R & E Grant Application 19-21 Biennium

Project #: 19-016

Port of Bandon ADA Fishing Pier

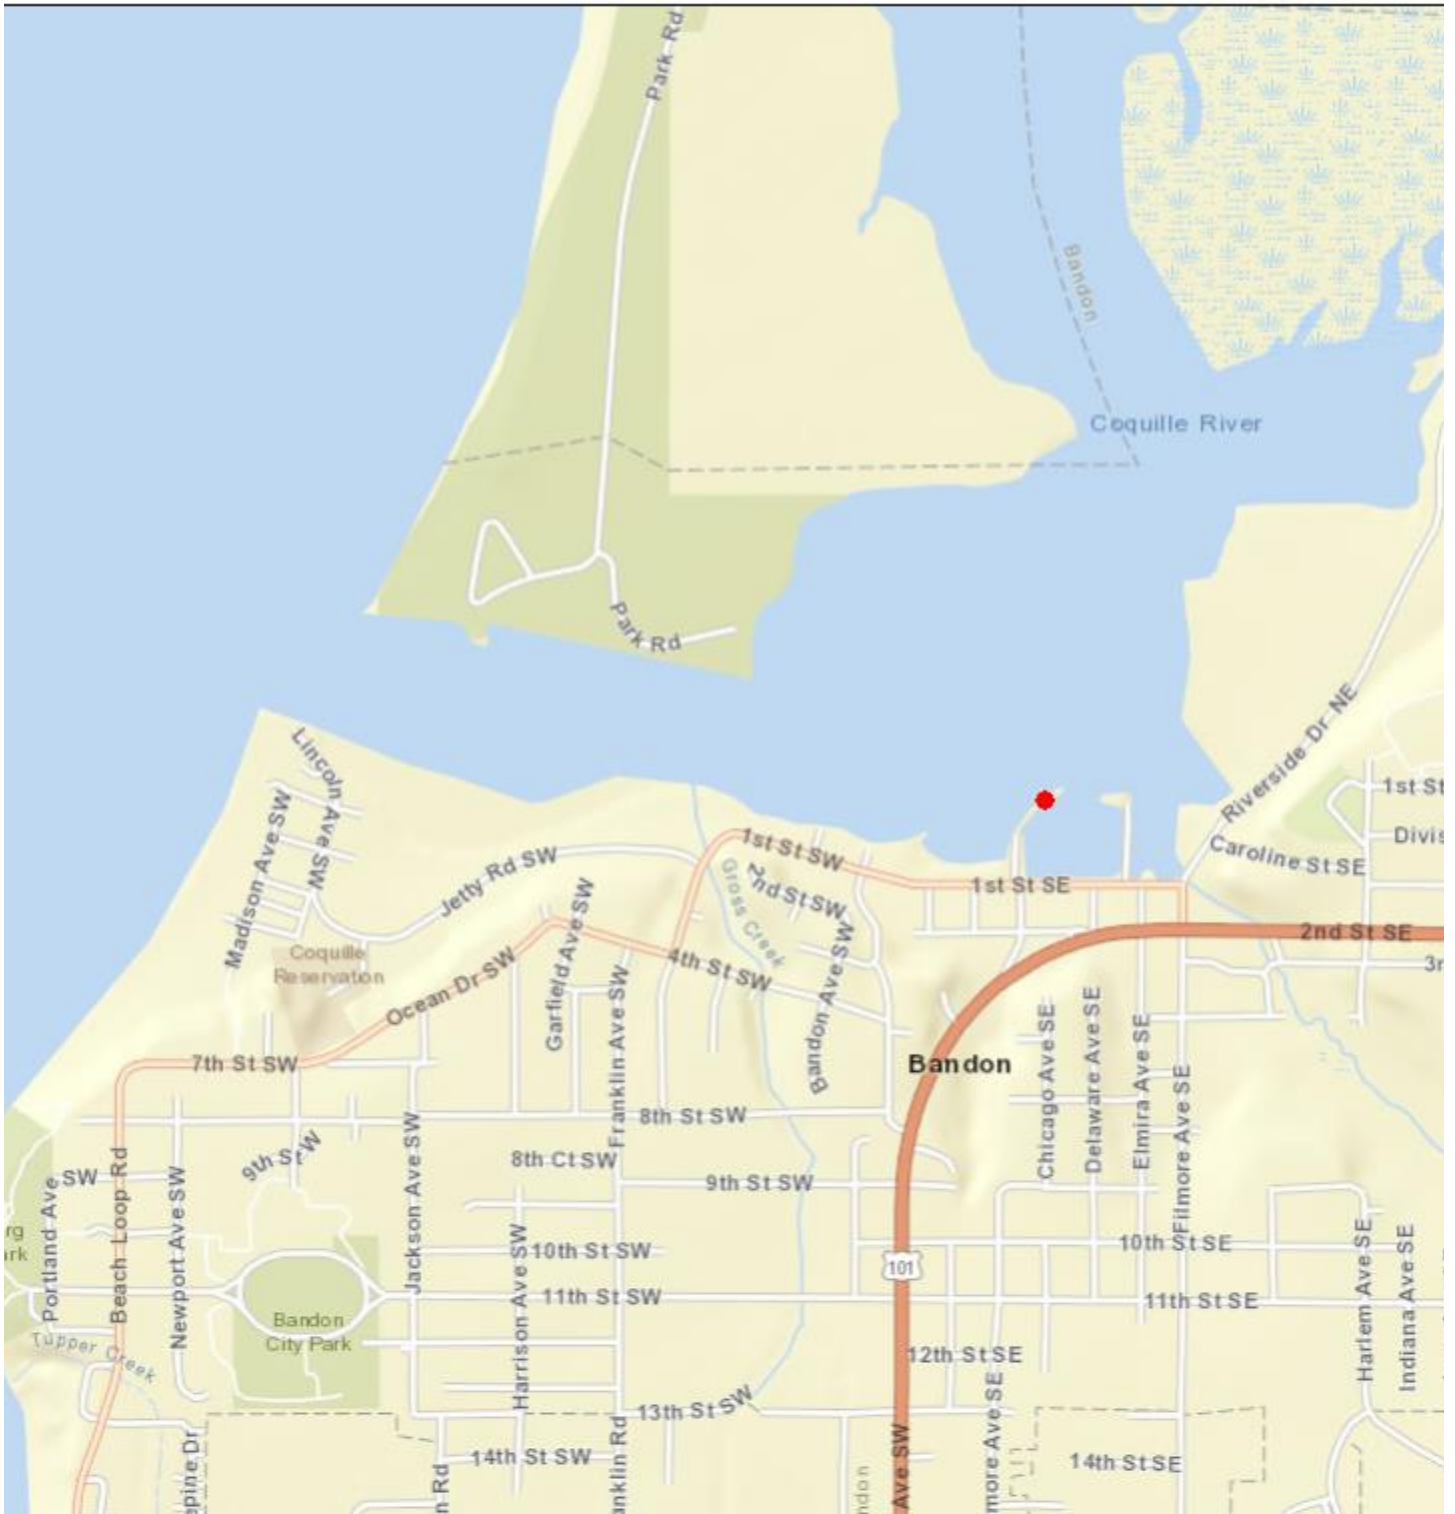
Please describe how the proposed solution will meet accessibility standards from where the person parks all the way to the point at which they are using the dock. Is there ADA parking available at this site? Does the number of spots and the space required meet the ADA standards for parking?

We will include in this project additional ADA parking spaces adjacent to the pier entrance on the high dock. That area is used for random parking now and has the room to designate the ADA spaces. This would be in addition to the spaces the Port already has on the nearby boardwalk.
